PLAN CHANGE 92 – SUMMARY OF CHANGES TO RECOMMENDATIONS BASED ON COUNCIL EVIDENCE – 6 SEPTEMBER 2023

The purpose of this document is to update the recommended changes which were published in the following documents at the time of releasing the Section 42A report:

Attachment A – Recommended Changes to District Plan Maps

Attachment B – Recommended Changes to District Plan Text

**ŌMOKOROA
 PLAN CHANGE 92
 PROPOSED ZONING MAP - 6 SEPTEMBER 2023**

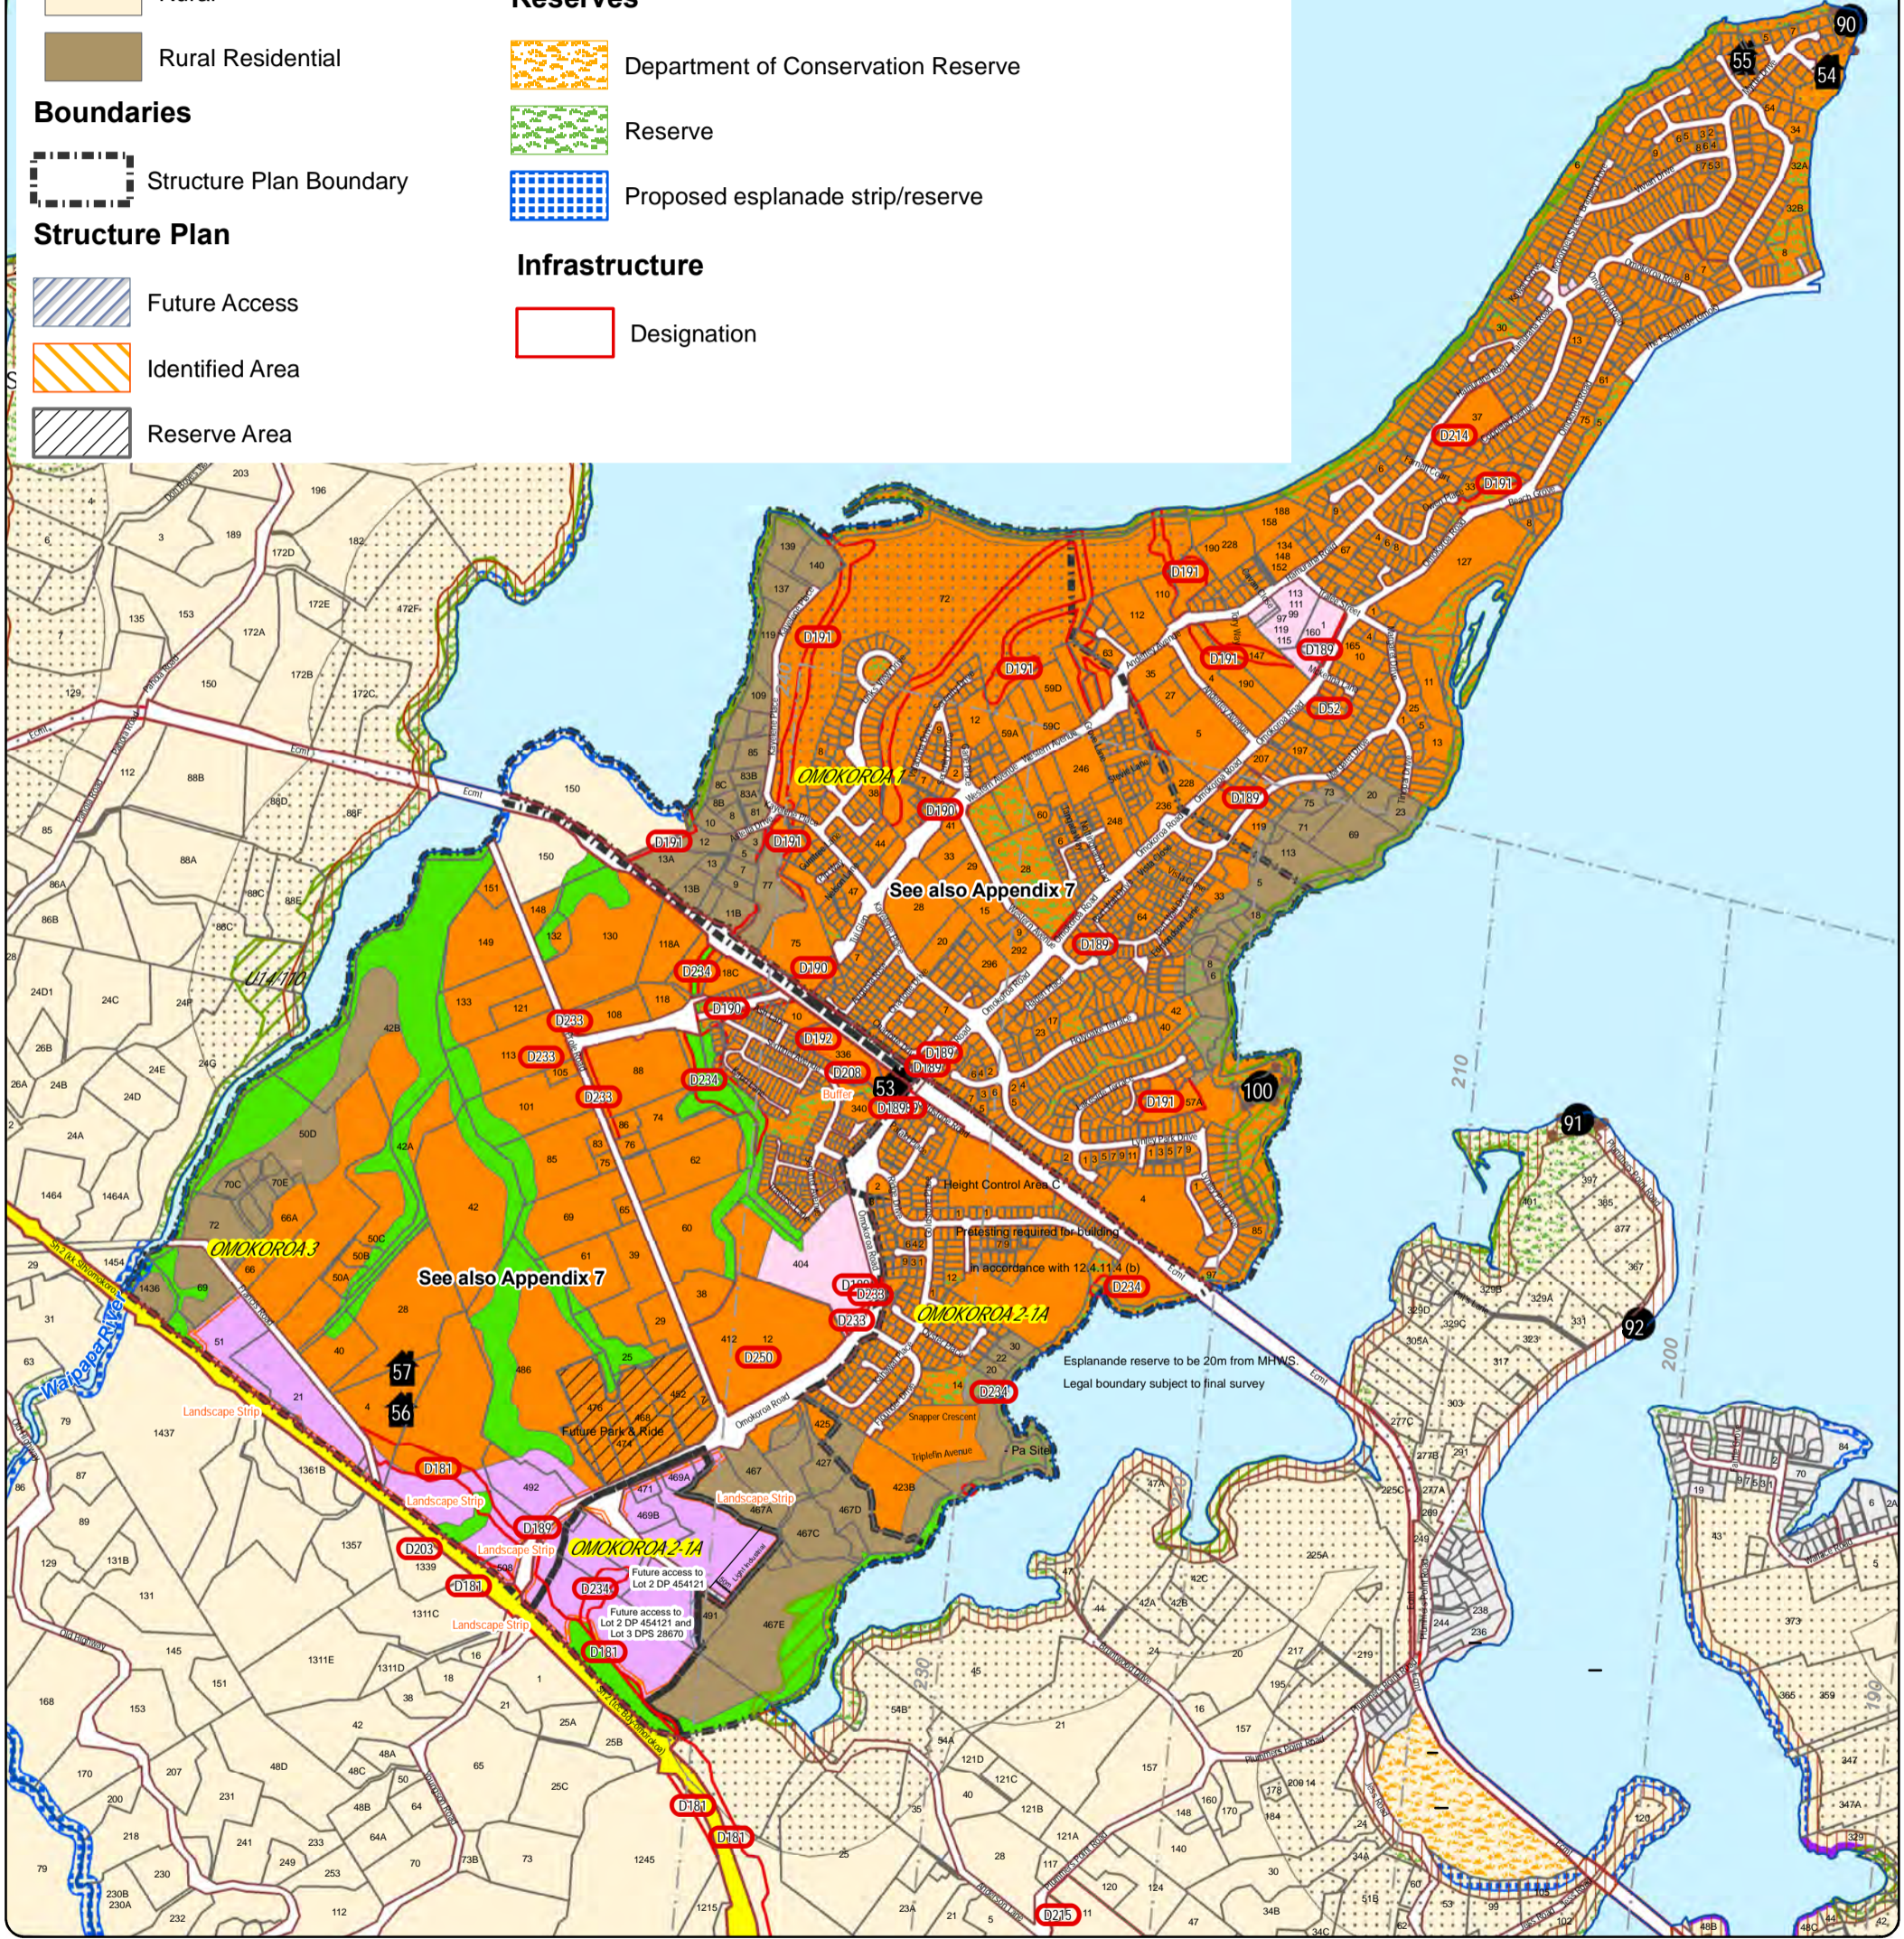
- **Ōmokoroa Plan Change 92 – Proposed Zoning Map:** Further amend the boundary of significant ecological feature U13/145, as it applies to 467E Ōmokoroa Road (M & S Smith) by removing the area shown as (b) in Plate 2 of the assessment from Nautilus Contracting Limited.

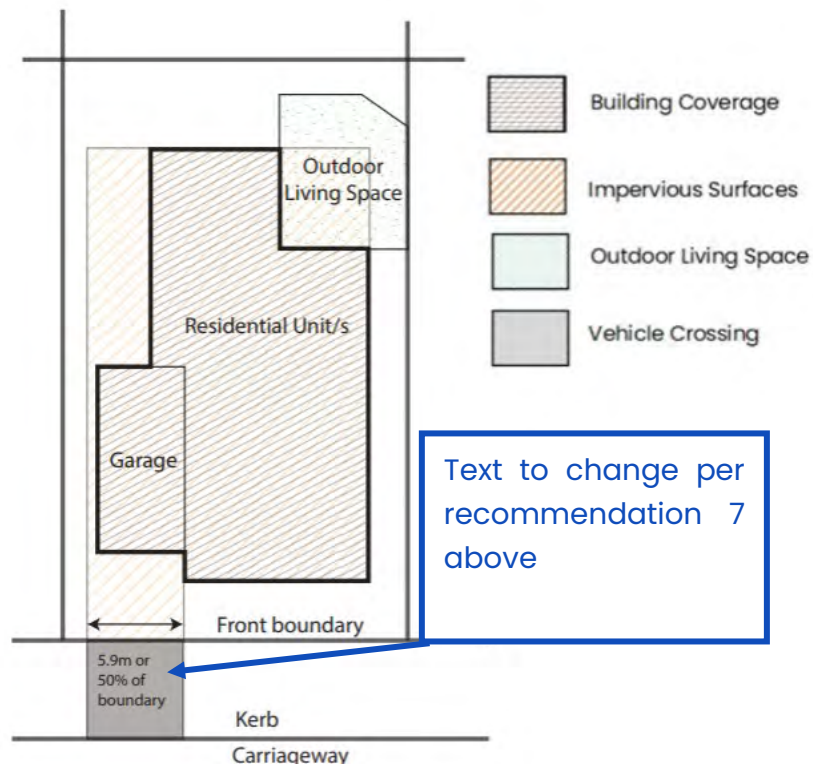
- i. For a site with a front boundary the vehicle crossing shall not exceed 5.4m in width (as measured along the front boundary) and shall not ~~or~~ cover more than ~~40%~~ 50% of the length of the front boundary as shown in the diagram below.

8. Amend the diagram under Rule 14A.4.2(e) to state to correct 5.9m to 5.4m.
